## Document Update Notification

**DOCUMENT NO:** OP-1903.067

**TITLE:** EMERGENCY RESPONSE FACILITY-  
EMERGENCY OPERATIONS FACILITY  
(EOF)

**SUBJECT:** PERMANENT CHANGE (PC)

- J. Position Guide J - Support Manager
- 7.1.2 Attachment 2 - "Emergency Operations Facility (Lower Floor)" Floor Plan and Room Assignments
- 7.1.3 Attachment 3 - "Emergency Operations Facility (Upper Floor)" Floor Plan and Room Assignments

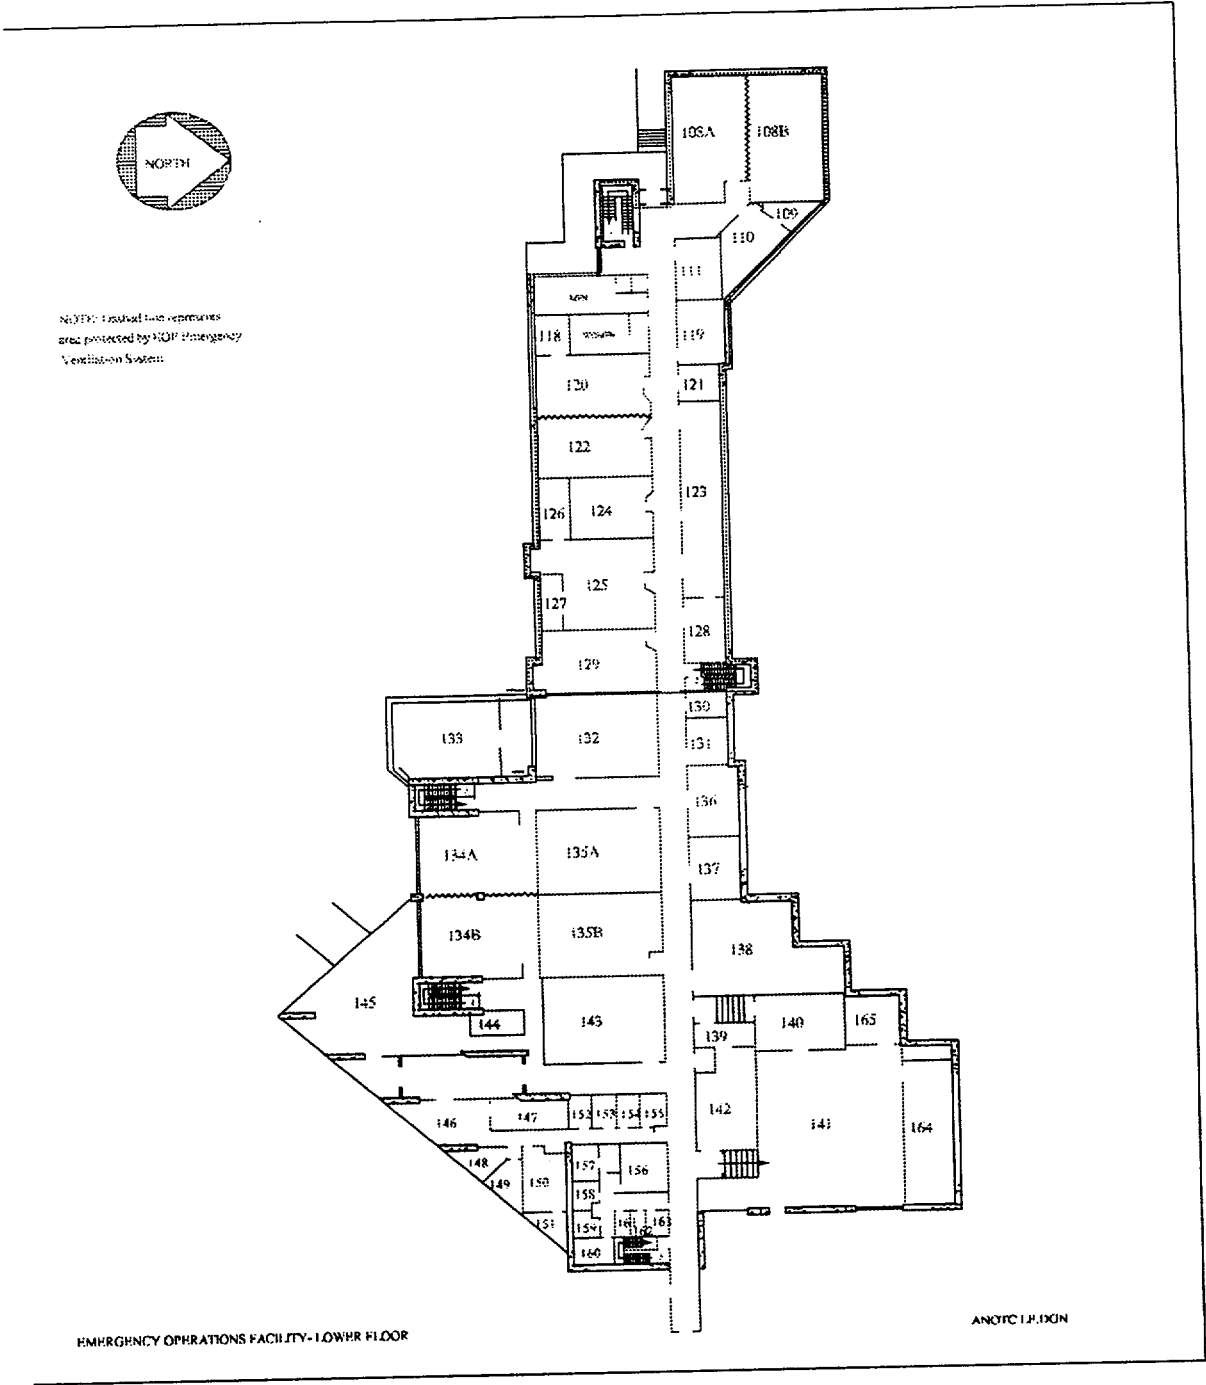
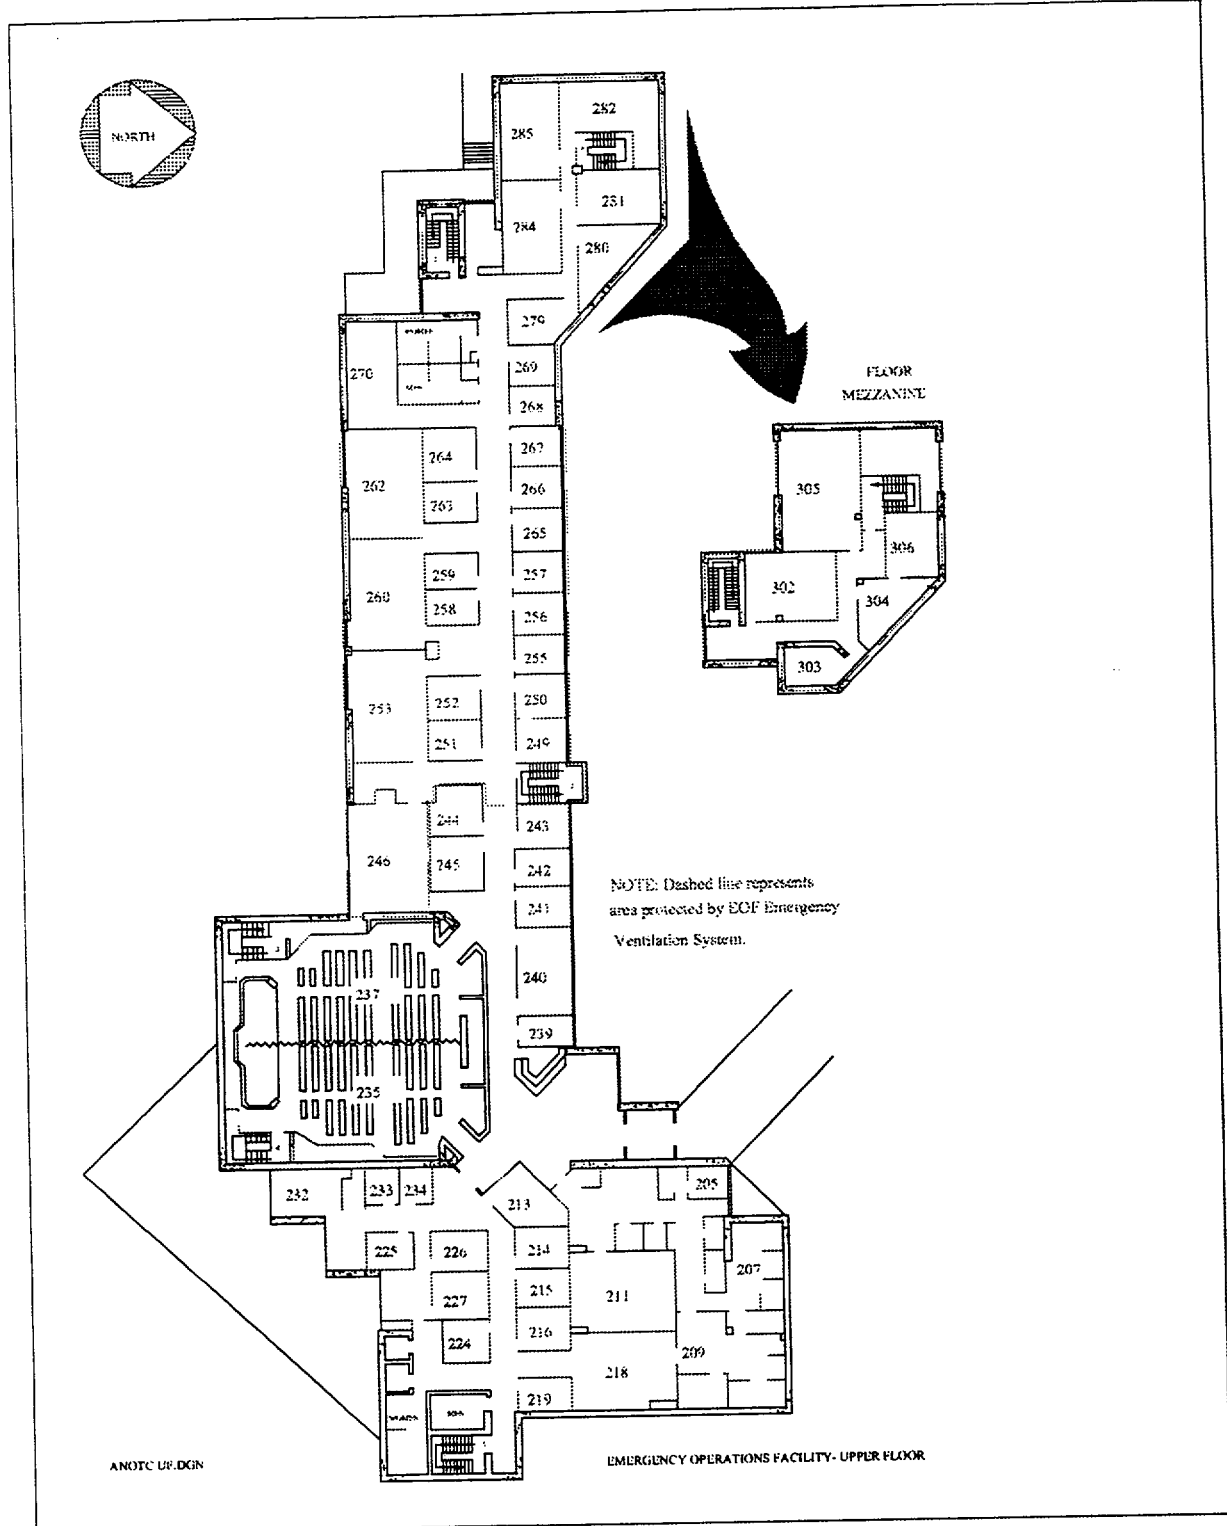
Changed room numbers for EOF Support Engineers. Added statement to retain one EOF Support Engineer in the Command Room.

Changed room numbers for EOF Support Engineers. Deleted reference to plant drawings in Black locker and Library. Added statement to obtain drawings from computer.
